World Forum for Harmonization of Vehicle Regulations

Working Party on Passive Safety

Report of the Working Party on Passive Safety on its sixty-fourth session

Figure 1
Arrangement for testing a forward-facing device

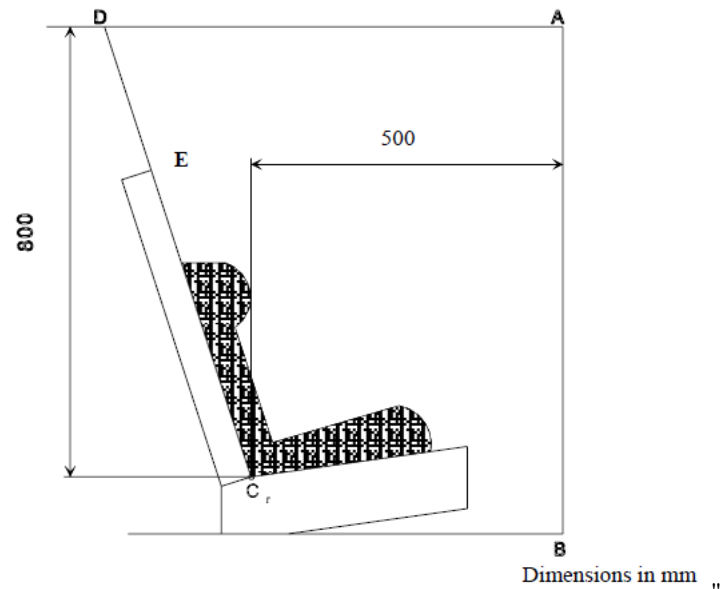
Paragraph 6.6.4.4.1.1., amend to read:

Head excursion: No part of the head of the dummy shall pass beyond the planes BA, DA and DE as defined in Figure 1 below. **However, the head of the dummy may pass beyond the DE plane, if there is part of the child restraint structure, i.e. head pad or backrest, behind the head of the dummy, at the point the head passes the DE plane.**"

Head excursion: No part of the head of the dummy shall pass beyond the planes BA, DA and DE as defined in Figure 1 below. **However, the head of the dummy may pass beyond the DE plane, if there is part of the child restraint structure, i.e. head pad or backrest, behind the head of the dummy, at the point the head passes the DE plane.**"

- (a) The value in relation to the DA plane is 840 mm; and
- (b) The value in relation to the BA plane is 550 mm; and
- (c) The rebound phase is not considered for the assessment of the plane DA and DE.

Annex 2., the example of approval markings only, amend to read:

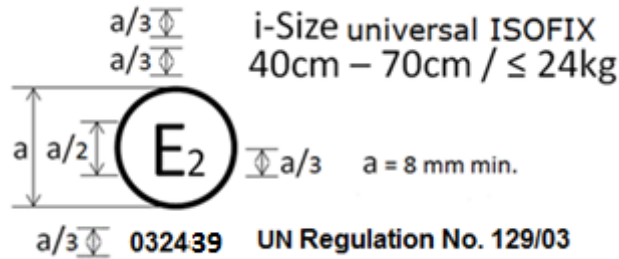
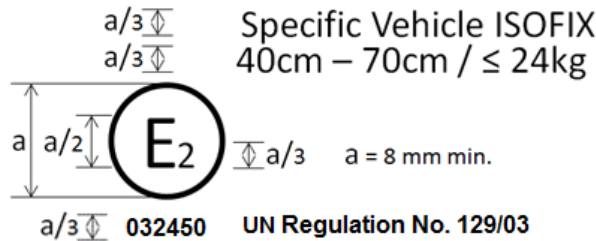
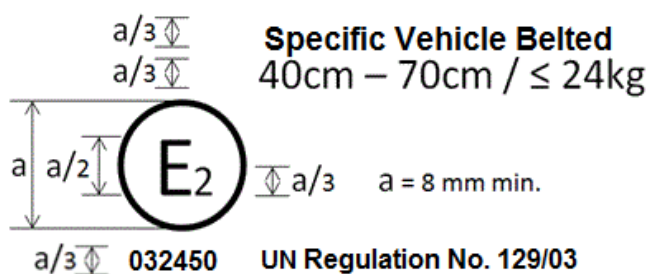
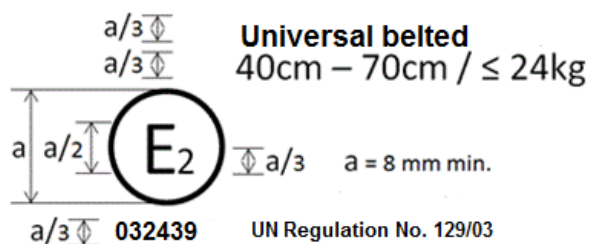
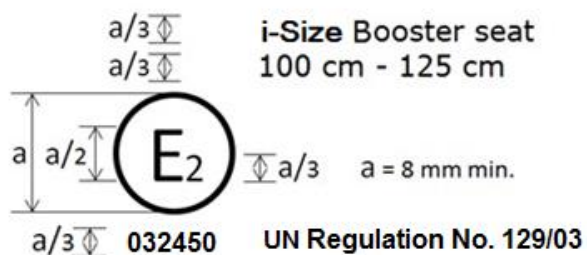
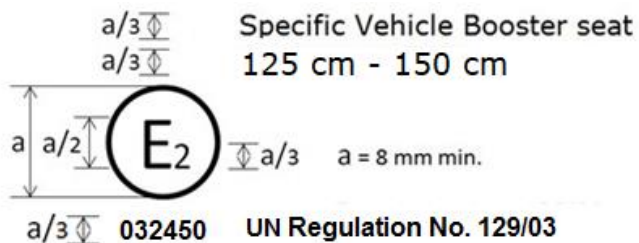
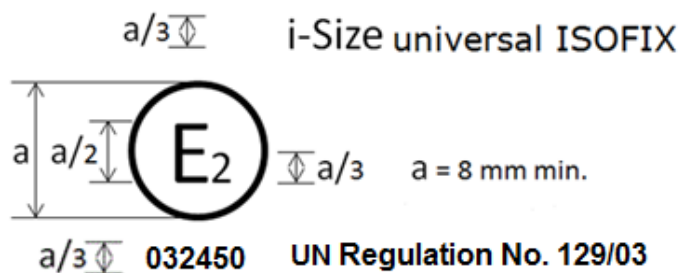
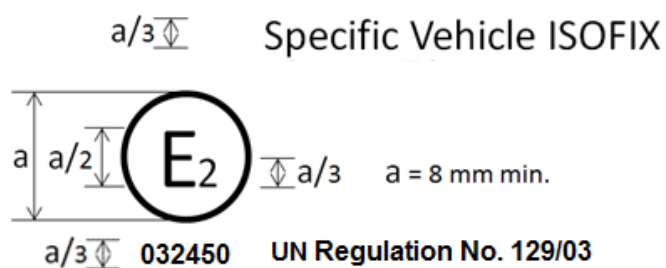
Adopted text based on GRSP-64-07 (see para. 30 to this report)

Annex 2., amend to read:

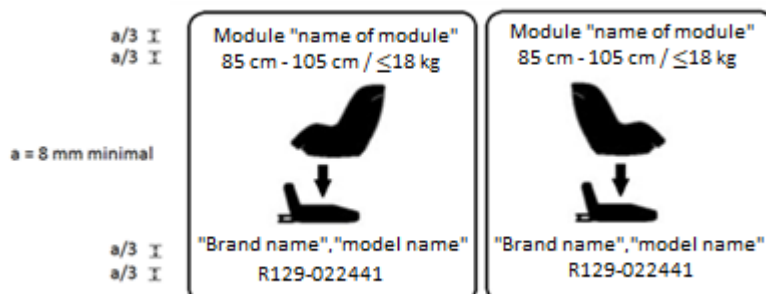
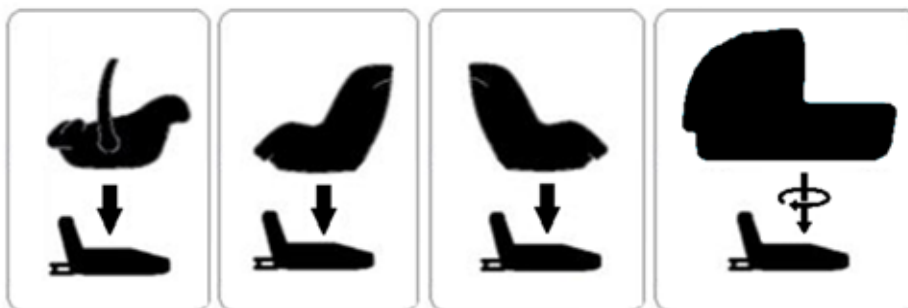
Adopted text based on GRSP-64-08-Rev.1 (see para. 30 to this report)

Current examples given to be deleted and replaced by the following:

The Enhanced Child Restraint System module bearing the above module marks is capable of being used in a rearward facing mode with the base "brand name and model name", for the 85 cm–105 cm size range and with a mass limit of 18 kg; approved according to UN Regulation No. 129-02 under the number 022441.

Annex 2., amend to read:

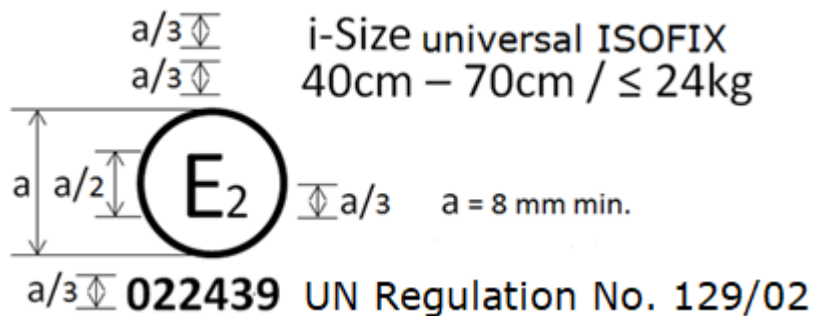
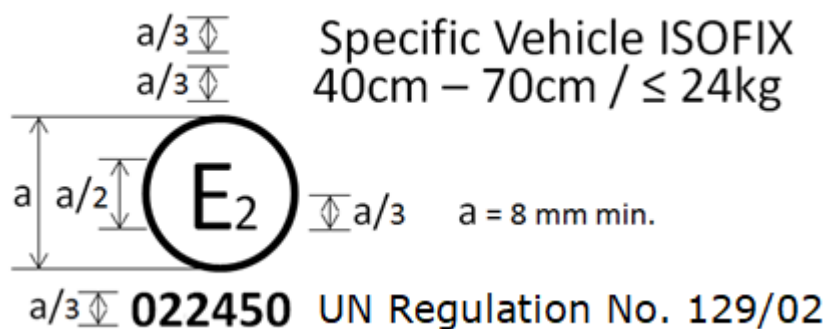
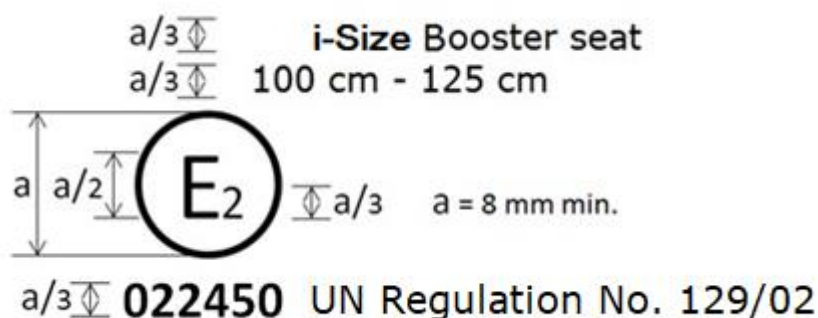
Adopted text based on GRSP-64-31 (see para. 30 to this report)

Paragraph 4.5., amend to read:

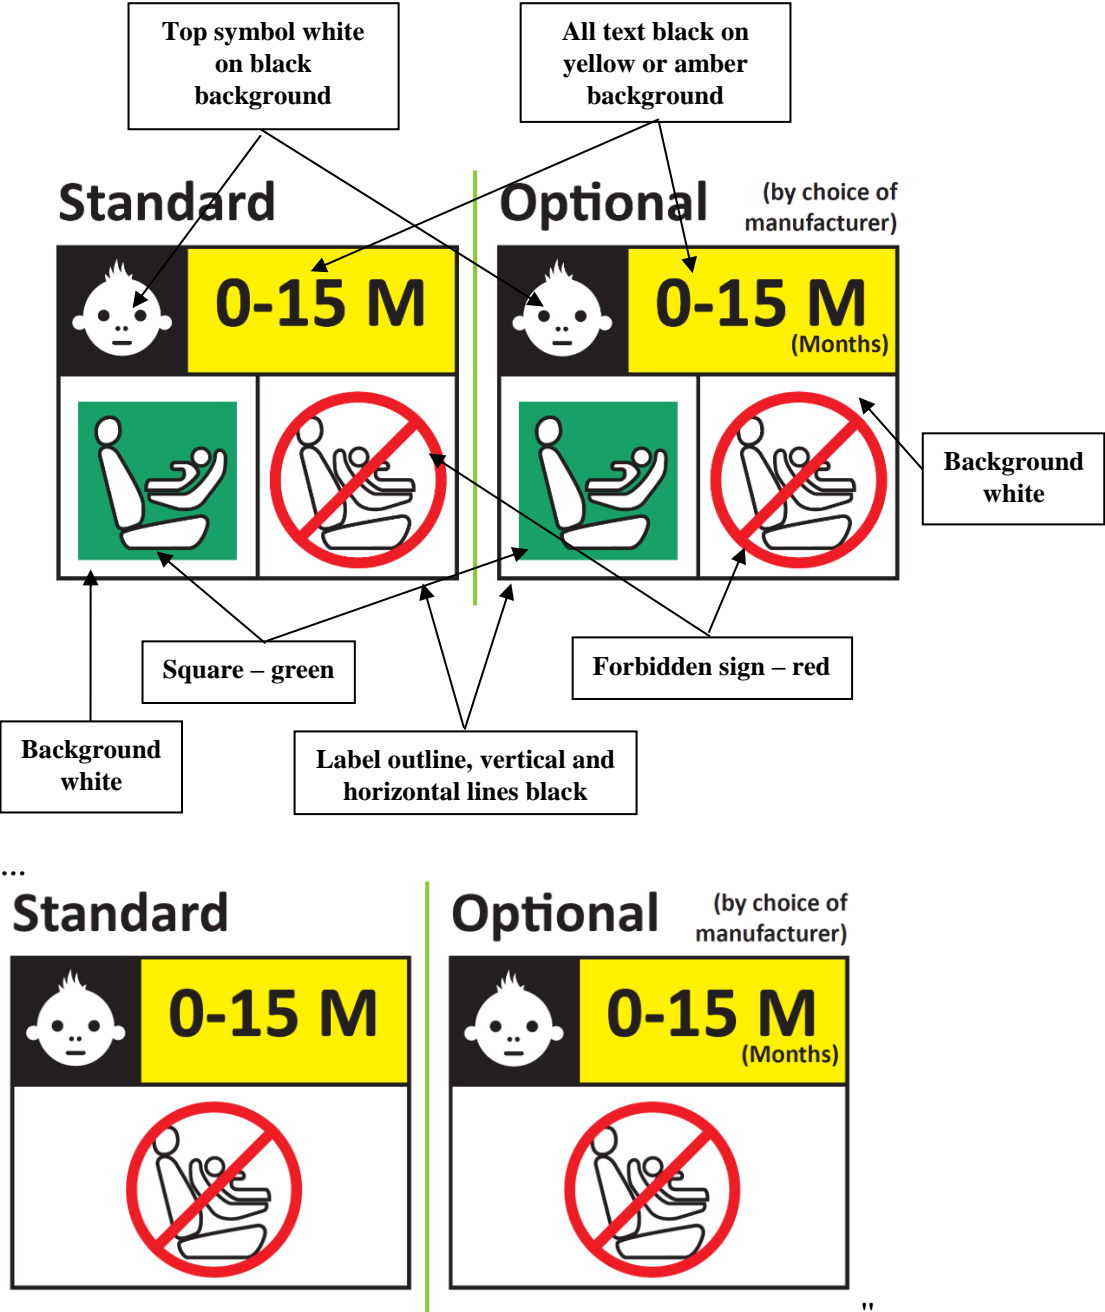
Amendments adopted to ECE/TRANS/WP.29/GRSP/2018/28 (see para. 31 of this report)
